**Table B**  
**Agency Submissions Responses**

Figure 1: Groundwater Investigation Programme

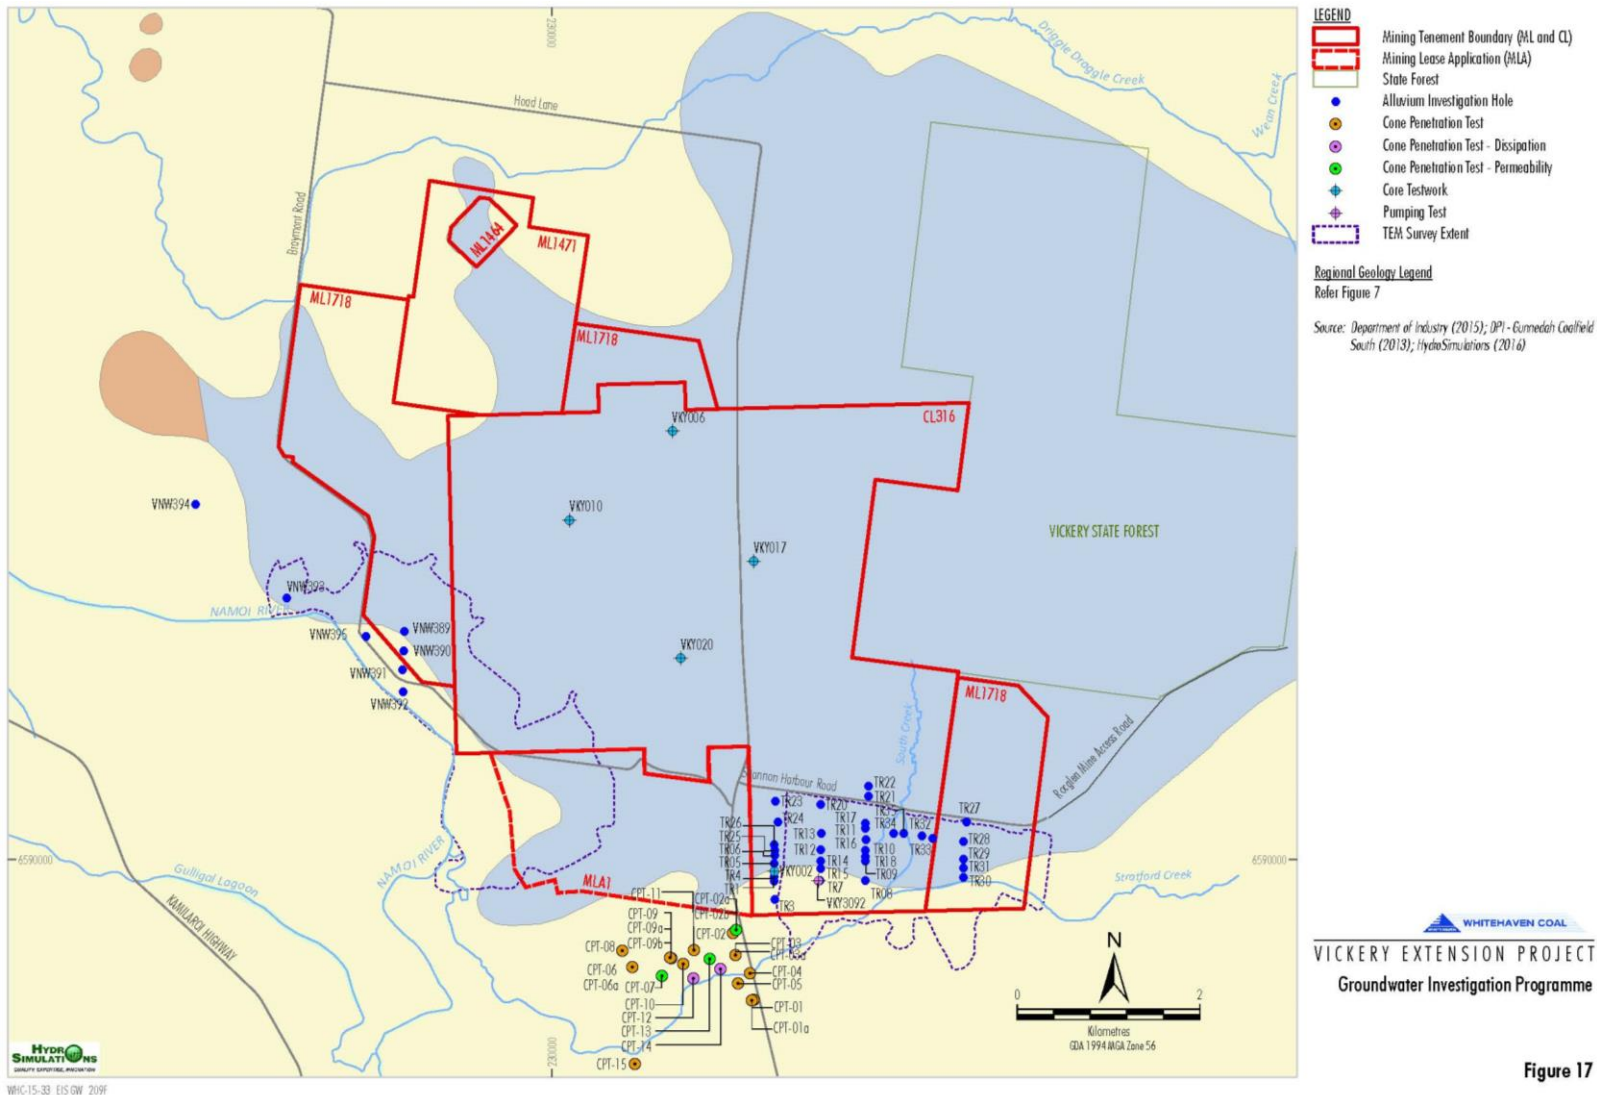
Recommendation		Response
<b>Groundwater</b>		
<b>1S</b>	<p><b>1) Final Void Design</b></p> <p><i>The proponent is to provide further discussion on alternate final mine landform and further justification for final voids if this remains the preferred option. Justification must include demonstration of how long-term impacts on ground and surface water quality (from salts and metals ingress) and existing groundwater flow paths will be maintained.</i></p>	<p>Please see response to Recommendation 10 in Table A (DPE Preliminary Issues Report Responses).</p>
<b>1T</b>	<p><b>2) Groundwater Quality Sampling Locations</b></p> <p><i>The proponent is to provide a detailed map clarifying the locations of all groundwater monitoring bores used for groundwater quality sampling.</i></p>	<p>Figure 17 of Appendix A of the EIS (reproduced below as Figure 1), which was included in EPA's submission, shows the location of test sites for the groundwater investigation programme undertaken to confirm the extent of the Namoi River Alluvium.</p> <p>Figure 16 of Appendix A of the EIS (reproduced below as Figure 2) shows existing groundwater monitoring locations within and in the vicinity of the Project area. Groundwater monitoring locations are also detailed in Section 2.9 of Appendix A of the EIS.</p> <p>The existing groundwater monitoring network would be reviewed as part of preparation of the Water Management Plan, with consolidation of the network as required.</p>

Figure 3: Koala Potential Habitat – Mining Area

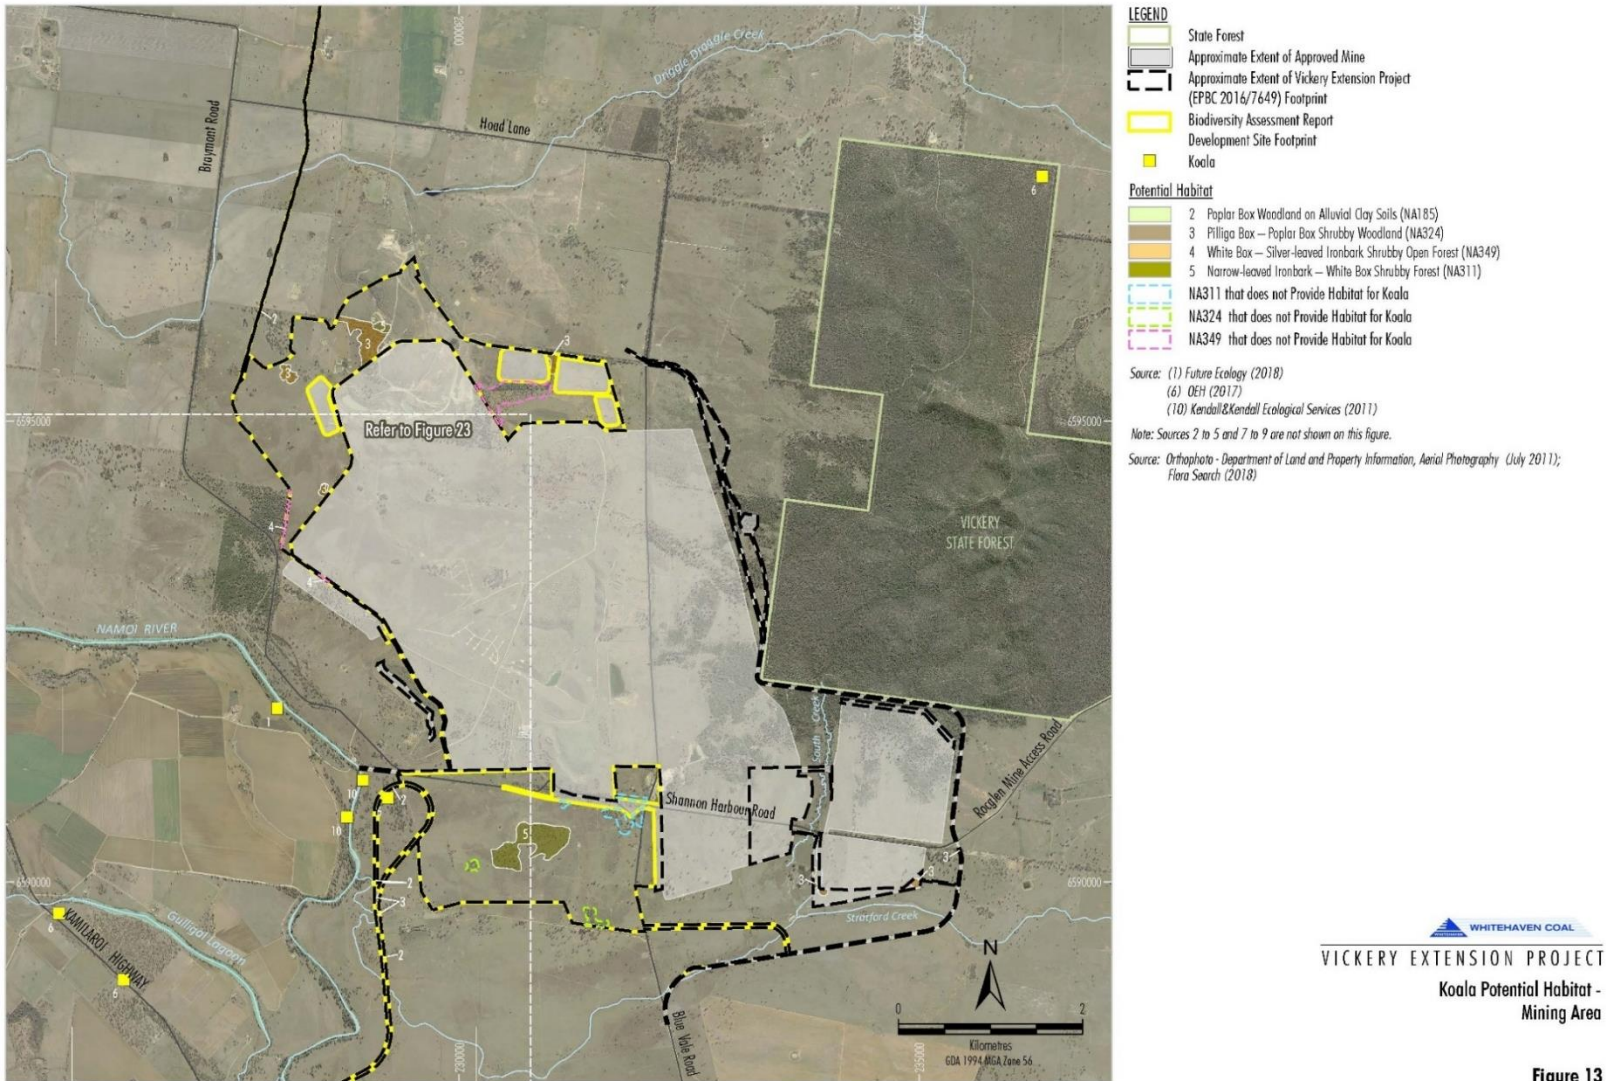
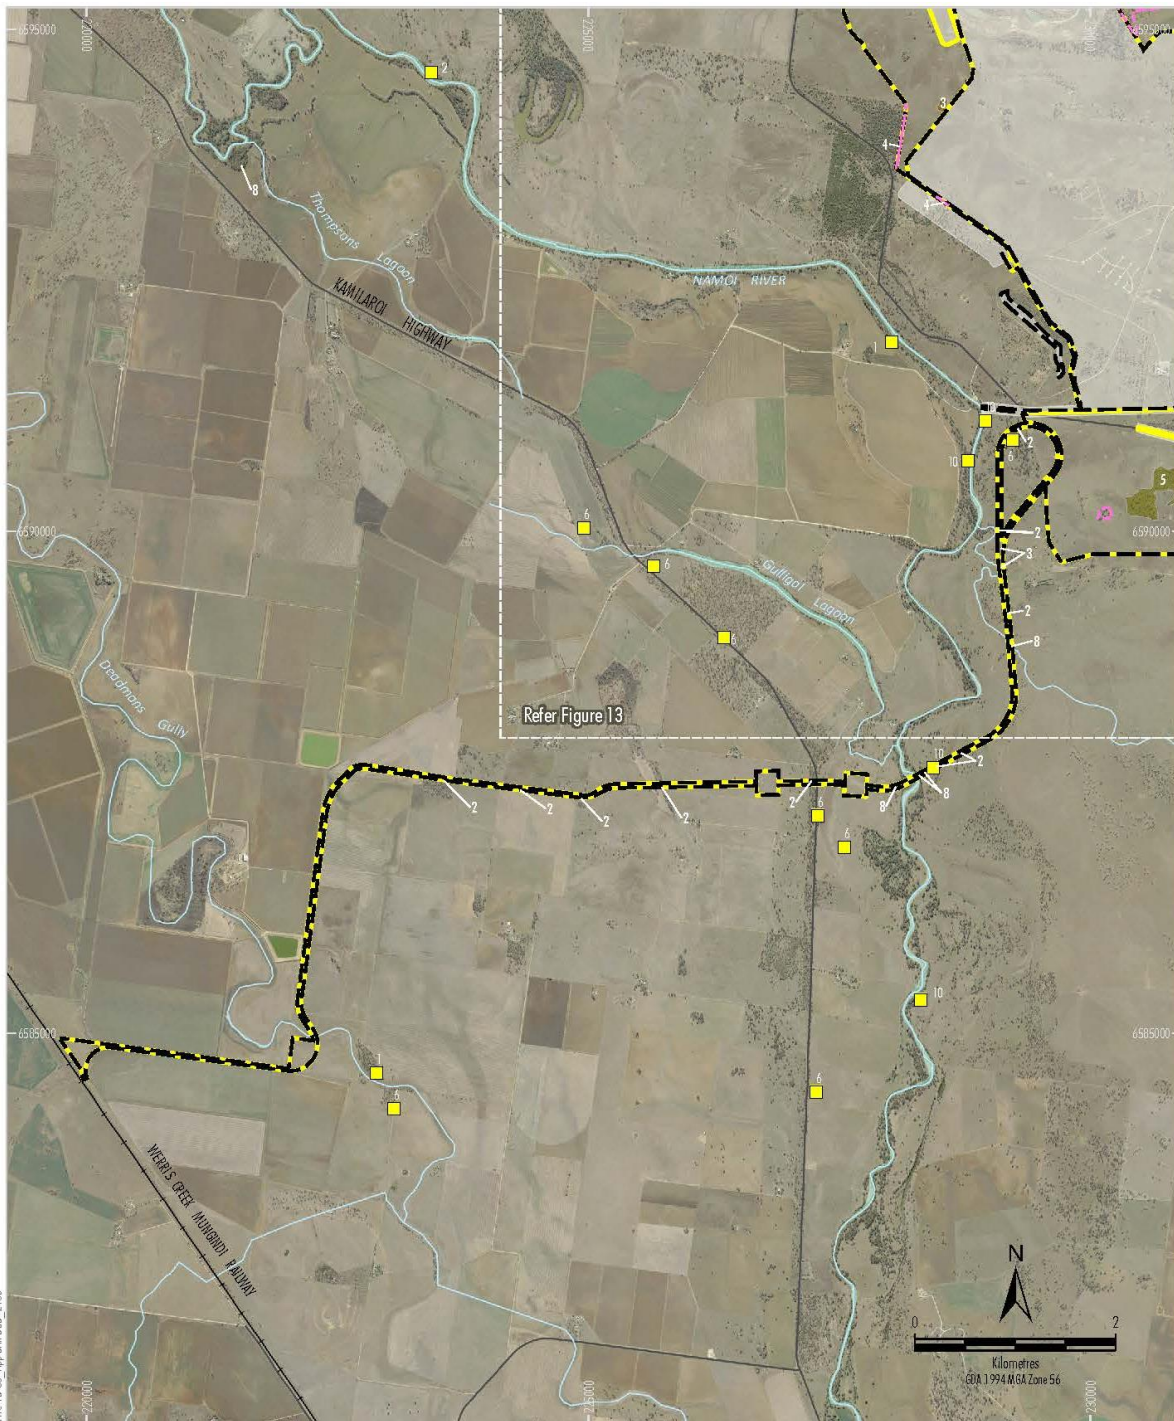
Recommendation	Response
2	OEH	
	<b>Biodiversity</b>	
2A	<p>1. <i>The species credit polygons for the koala should be increased from 44.6 hectares to 72.6 hectares at the mine site. The subsequent species credit liability for the koala should be updated and offset appropriately.</i></p>	<p>Whitehaven intends to work with the NSW Office of Environment and Heritage (OEH) to finalise the biodiversity offset requirements for the Project. The following provides an initial response to OEH’s comments.</p> <p>The species credit polygon mapped for the Koala (Figures 13 and 23 of Appendix F of the EIS, reproduced as Figures 3 and 4 below) is consistent with <i>State Environmental Planning Policy No 44 – Koala Habitat Protection</i> (SEPP 44) and the <i>NSW Recovery Plan for the Koala</i> and covers all potential habitat in the vicinity of records of the Koala near the Namoi River. OEH requests that the Koala species credit polygon be expanded to also include other tree species (which are not listed in SEPP 44 or the <i>NSW Recovery Plan for the Koala</i>) in patches and scattered trees further away from the Namoi River, where the Koala has not been recorded and is considered unlikely to occur due to a lack of primary feed trees.</p> <p>Whitehaven is concerned that OEH’s proposed approach for mapping the Koala species credit polygon in the Project area will not be applied equally to the proposed offset areas for the Project, due to the differences in assessment processes that will apply to the offset areas.</p> <p>Whitehaven is aware that offset areas for the Project will need to be secured under the <i>NSW Biodiversity Conservation Act, 2016</i> (BC Act) (or other acceptable mechanism) in accordance with the Biodiversity Assessment Method (BAM) and credits generated under the BC Act are not equivalent to those generated under the <i>NSW Threatened Species Conservation Act, 1995</i> (TSC Act). It is understood that OEH considers the ‘reasonable equivalence’ of biodiversity credits on a case by case basis.</p> <p>Under the BC Act, the Koala is now a species credit species only within ‘important’ habitat that will be mapped by OEH. It is understood that species credits are not required for a development site, and cannot be generated at an offset area, unless within a mapped ‘important’ habitat.</p> <p>Increasing the Koala species credit polygon to 72.6 ha in the NSW Assessment Footprint and 108.9 ha in the Commonwealth Assessment Footprint would be subject to further discussion with OEH, particularly with respect to consistency with OEH’s mapping of ‘important’ habitat under the BC Act.</p> <p>Note that Quadrat 10 is not in NA324 (as mentioned by OEH) but is in NA185, outside the development footprint. Therefore it is not relevant to the Koala species credit polygon.</p>

**Figure 4: Koala Potential Habitat – Project Rail Spur**

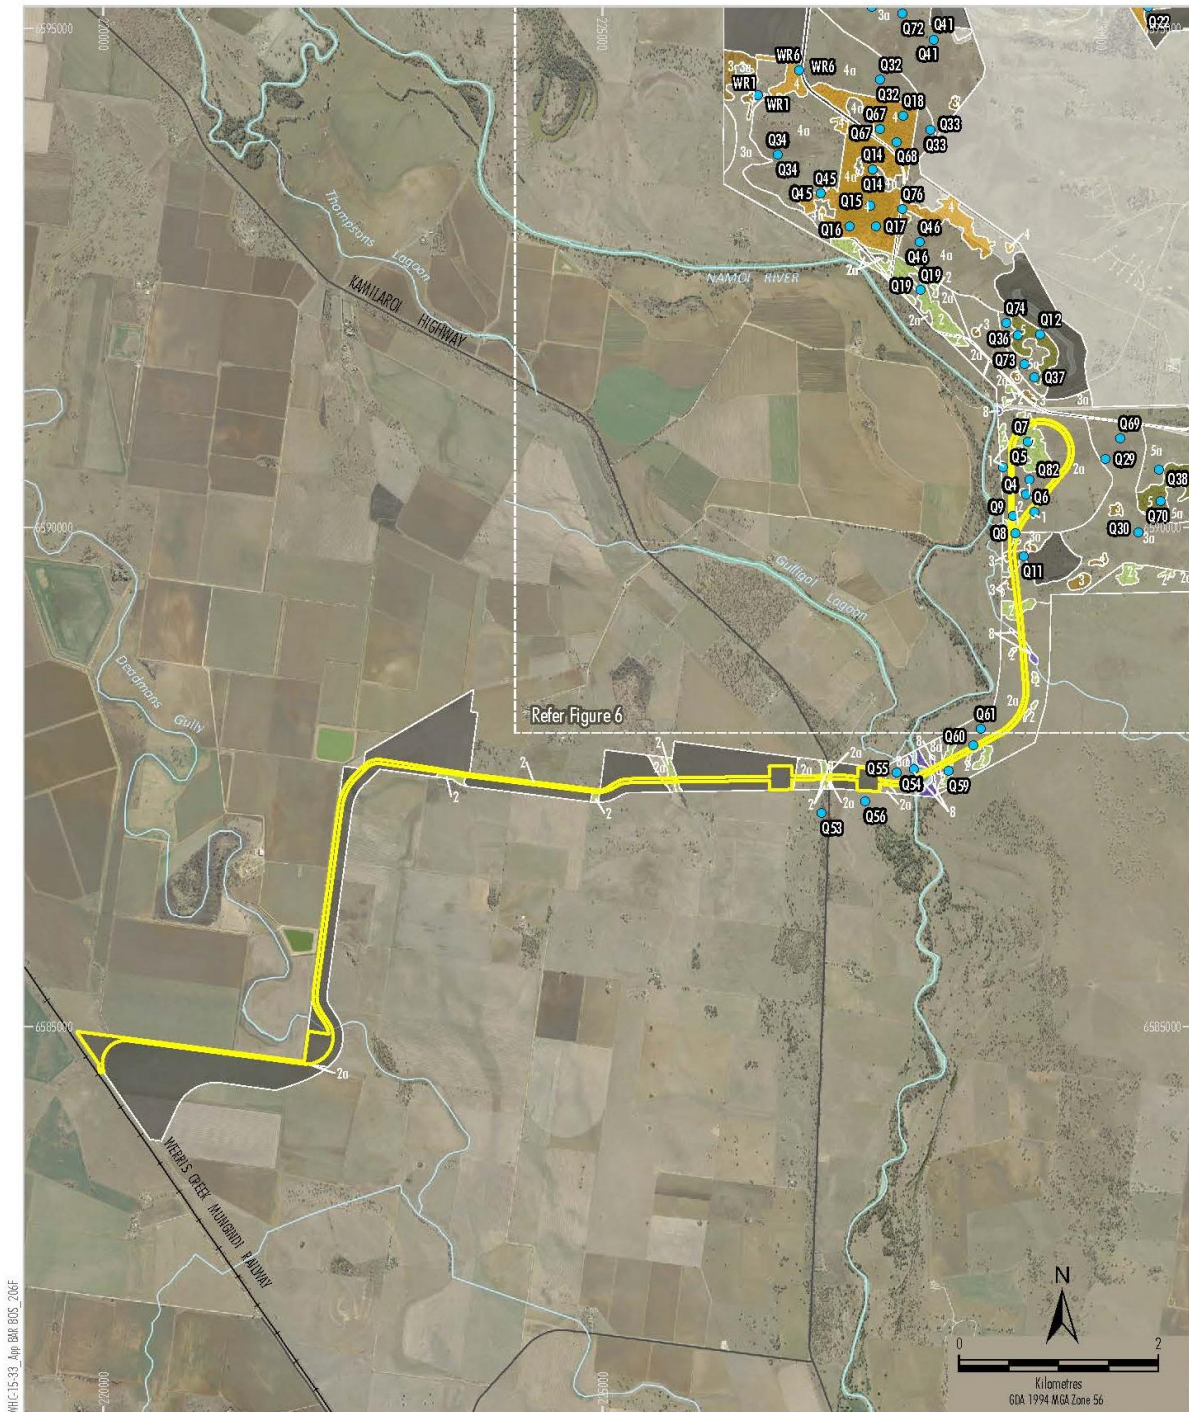
Recommendation	Response
<b>2B</b>	2. <i>The species credit polygons for the koala in the Commonwealth assessment footprint should be reviewed and updated. The subsequent species credit liability for the koala should be updated and offset appropriately.</i>	<p>Increasing the Koala species credit polygon to 108.9 ha in the Commonwealth Assessment Footprint (and 72.6 ha in the NSW Assessment Footprint) would be subject to further discussion with OEH, particularly with respect to consistency with OEH’s mapping of ‘important’ habitat under the BC Act (see response to submission 2A).</p> <p>Whitehaven intends to work with OEH to finalise the offset requirements for the Project.</p>
<b>2C</b>	3. <i>The proposal to develop a Koala Management Plan for the Vickery Extension Project should be captured in the project approval.</i>	<p>Whitehaven is preparing a Koala Plan of Management for the Project that describes measures to manage the impact to koala habitat along the Namoi River, in accordance with <i>State Environmental Planning Policy No 44 – Koala Habitat Protection</i>.</p> <p>The Koala Plan of Management will be provided to DPE and OEH for review as a component of the Responses to Submissions. The final Koala Plan of Management will be made available on Whitehaven’s website.</p>

**Figure 5: Flora Survey Sites – Project Rail Spur**

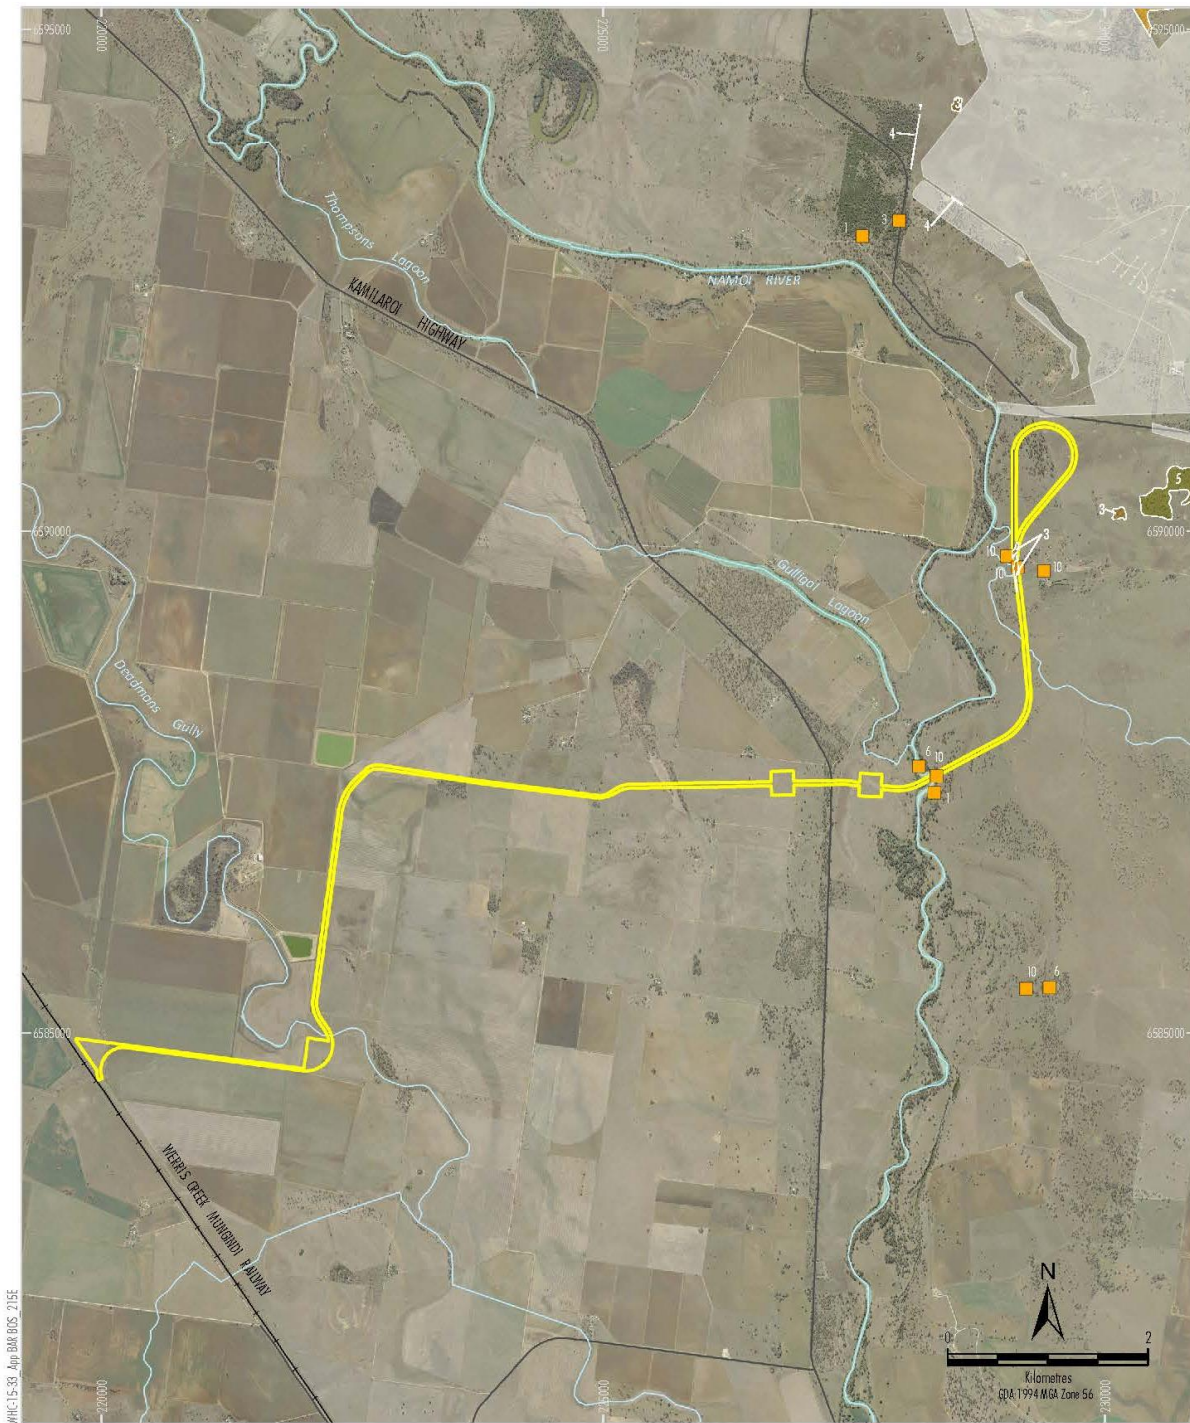
<b>2D</b>	4. <i>Further justification should be provided to explain why NA185 (poplar box woodland on alluvial clay soils) would not be used as habitat by the squirrel glider.</i>	<p>Figures 19 and 24 of Appendix F of the EIS (reproduced as Figures 5 and 6 below) show that the records of the Squirrel Glider are within NA324 and NA193, both recognised in the OEH’s <i>Archived BioMetric and Threatened Species Profiles Datasets</i>. OEH’s <i>Archived BioMetric and Threatened Species Profiles Datasets</i> does not recognise NA185 as habitat and the Squirrel Glider was not recorded in NA185.</p>
